SERVICE BULLETIN

174798-B1

Product: Lifestyle® CD5

Subject: Dim VFD Display

CD5 Power Supply

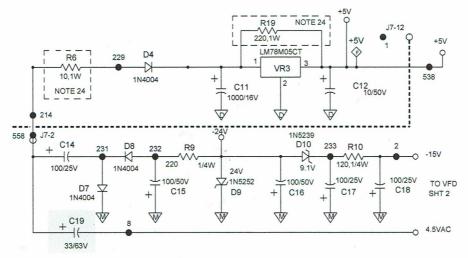
Symptom: Dim VFD Display.

Reason: Improper voltage rating on C19.

Solution: Replace C19 with a 33uF, 63V capacitor, part number 149948-3301J.

The display dims on some units, after the unit has been in use for a period of time. When a unit is returned from the field for service, C19 should be checked to ensure that the voltage rating on C19 is 63V. If it is not, it should be replaced with a 33uF, 63V capacitor, part number 149948-3301J. This should be done to all units returned for service to ensure this failure does not occur in the future. Refer to the schematic below, the CD5 service manual, part number 174798, and the CD5 supplement, part number 177871, for schematics, PCB layouts and disassembly procedures.
